## Global Nuclear Fuel

Subject: GNF-A's Response to the NRC's 5/26/04 RAI for the Model RA-3 Package –  
TAC No. L23695

## **Response To NRC RAI For Model No. RA-3**

**GNF-A Response: 6-1.b – Explain difference between previous and new low moderation results**

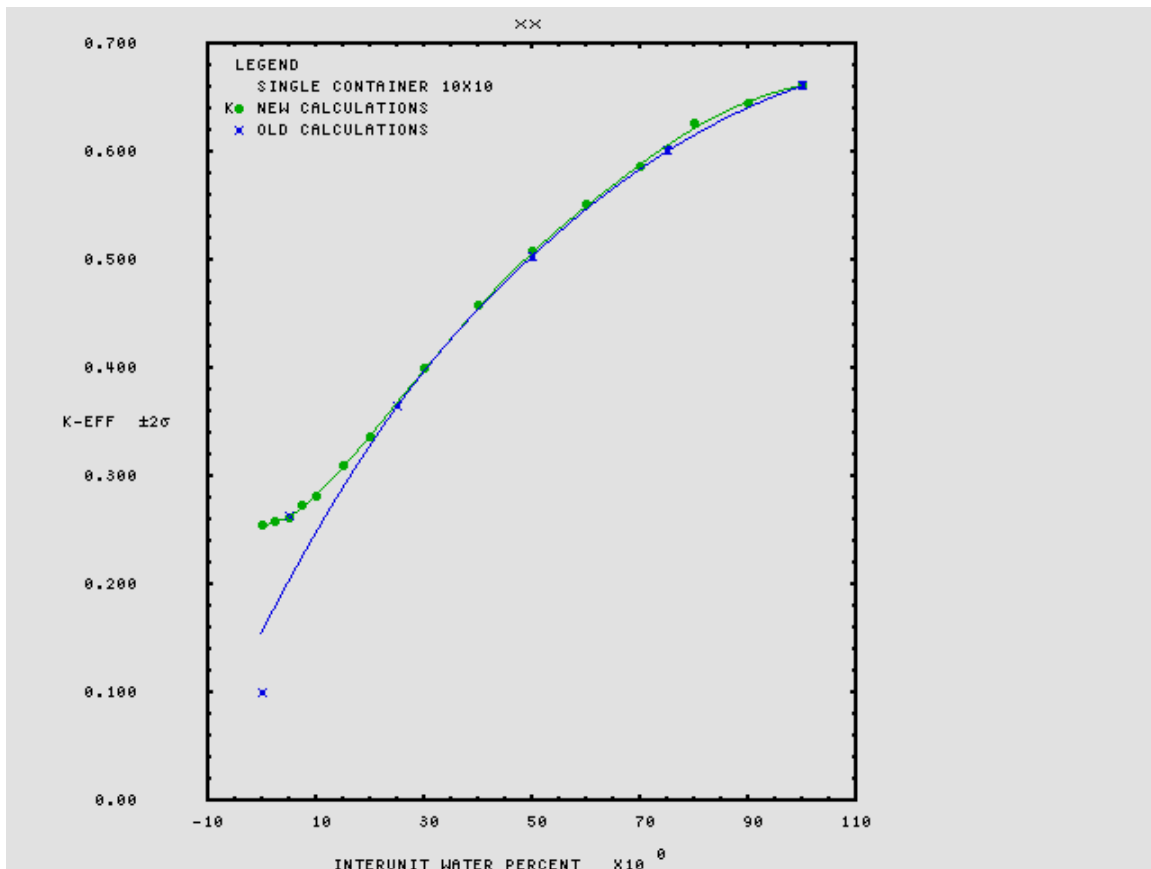
*Additionally, for the single undamaged package model, the k-effective results significantly differ between the previous code system and the code system used in the amendment application for low inter-unit water densities (less than 5% of full density water). In comparison, for the array models, results from the two code systems appear to closely agree for the same low inter-unit densities. While this low water density region is not of interest for the single undamaged package model, it is important in the analysis of package arrays. Thus, the question arises as to why the two code systems' results significantly differ for the single undamaged package model when the results for the array models closely agree and the purpose of the applicant's comparison is to demonstrate that the two code systems are equivalent.*

New calculations of the single, undamaged package results for the generic 10x10 fuel design were compared to previous results with the generic 10x10 fuel assembly in Figure 4.1-1. Excellent agreement is observed except for low interunit water. While it appears that this difference occurs over a range of interunit water, there is only one value that actually differs. The previous results were only provided at 0, 5, 25, 50, 75, and 100% of full density interunit water.

The figure shows that the results are the same for the two analyses at 5% interunit water. The previous result is significantly lower than the new result at 0% interunit water. It is obvious from the consistency of the new results and the agreement at 5% interunit water that the problem lies with the previous result at 0% interunit water.

As indicated in the question, the concern is not with the single unit calculations but with the undamaged container array calculations that are most limiting at 0% interunit water. The previous undamaged container array result for the GE8 model is  $0.9358 \pm .0010$ . The new result is  $0.93568 \pm .00057$ . This is excellent agreement and indicates no problem with the previous undamaged container array calculation.

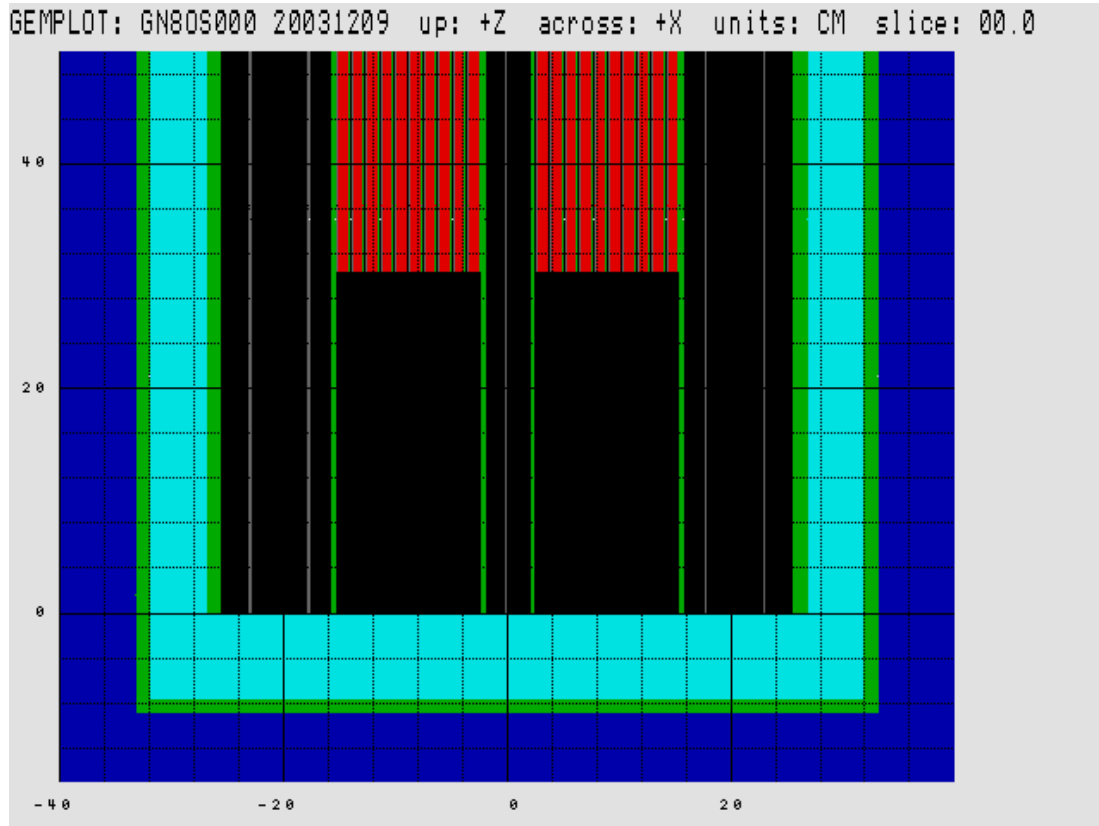
*There appear to be instances of intersecting volumes in the sample GEMER input files where one object is placed inside another that is smaller in one dimension than the body being placed in it. There also appear to be instances in the input files where portions of multiple bodies are intersected with a large body occupying the same volume and location as the portions of the multiple bodies it intersects. For example, the units labeled 'top water' and 'bottom water' and the array of fuel rods making the fuel assembly are placed in the cluster separator. However, the water that is modeled to extend above and below each fuel rod appears to occupy the same space as the top and bottom water units, respectively, causing multiple intersection of bodies in the same region.*

*Additionally, the top and bottom water units have the same cross-sectional dimensions as the cluster separator unit into which they are placed, this would apparently mean that the cluster separator is not modeled beyond the modeled fuel rods. Yet, the figures and explanation of the models in the application test indicate the cluster separator extends above and below the fuel rods.*

The specific question regarding 'top water' and 'bottom water' is a good one. As described in the previous paragraph, box type 25 is embedded into box type 24 and fits exactly at the top of box type 24. Next, box type 26 is embedded into box type 24 and fits exactly at the bottom of box type 24. Next, box type 23 is embedded into box type 24, filling box type 24 except for a small gap at the four

This is the way the RA-3 was modeled previously. Since the primary objective of the current analysis was to demonstrate no significant change in k-effective for the GNF2 fuel relative to the generic 10X10 fuel assembly, this treatment was not changed.

To consider the effect of extending the cluster separator backbone beyond the ends of the fuel, the most reactive case of the normal array with cluster separator (GN8N000) and the most reactive case of the damaged package array (GN8A-007) were modified to terminate the backbone at the ends of the fuel. This was accomplished by changing the  $\pm Z$  cuboid dimensions in BOX TYPES 1, 8, 9, 10, 11, 14, 15, 16, 17, 18, 19, 20, 21, 22, 23, and 24 to 411.48 30.48. Then, instead of embedding BOX TYPES 25 and 26 into BOX TYPE 24, they are embedded

OLD MODEL	KEFF	SIGMA	NEW MODEL	KEFF	SIGMA	% CHANGE
GN8N-000	0.85746	0.00075	GN8N-NOC	0.86646	0.00081	1.05%
GN8A-007	0.93928	0.00081	GN8A-NOC	0.93986	0.00081	0.06%

This study shows a one percent increase for the undamaged container array (as expected for overmoderated RA-3 container design). However, this result is still much less than the infinite undamaged container array without cluster separators (GN8NX000) for which keff = 0.93658. For the damaged container array, the change is well within the uncertainty of the calculations. This insignificant change is expected since the damaged container array is only one container long, unlike the undamaged container array which is an infinite number of containers long.

Figure 3.4-1 - X-Y Plot of Single Undamaged RA-3 Unit

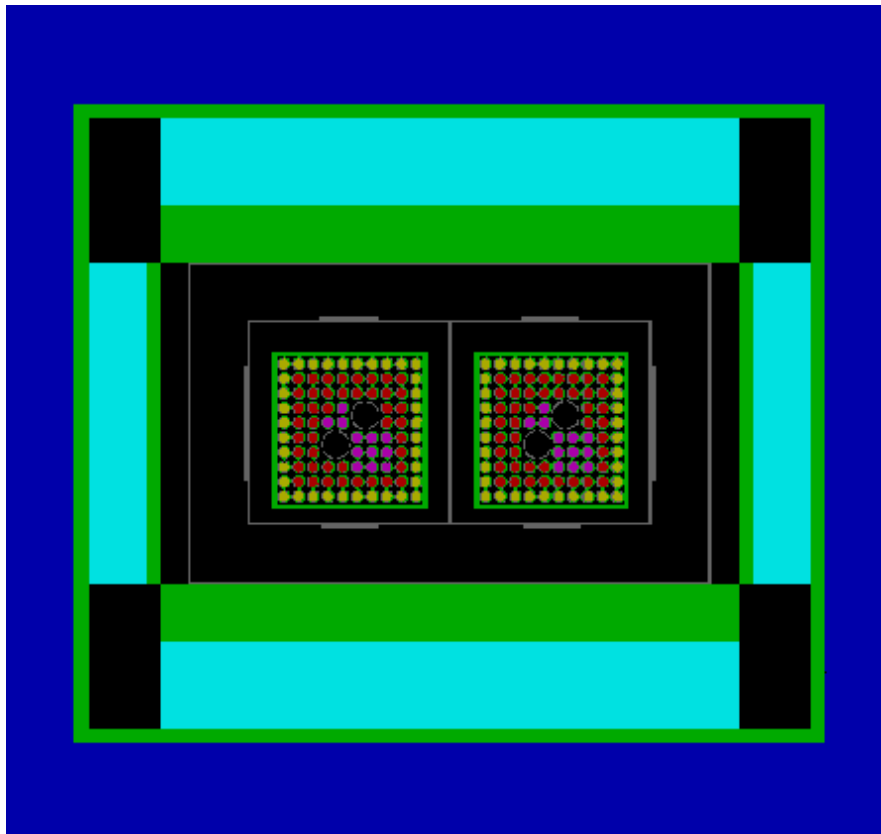
*6-8 Clarify the description of the material included in the model as having half-density honeycomb and no ethafoam present. However, the test following this list references the accompanying Figure 3.4-1 and states that the figure shows the model with half-density ethafoam and no honeycomb.*

#### **GNF-A Response: 6-8 – Clarify description of materials in model of undamaged array**
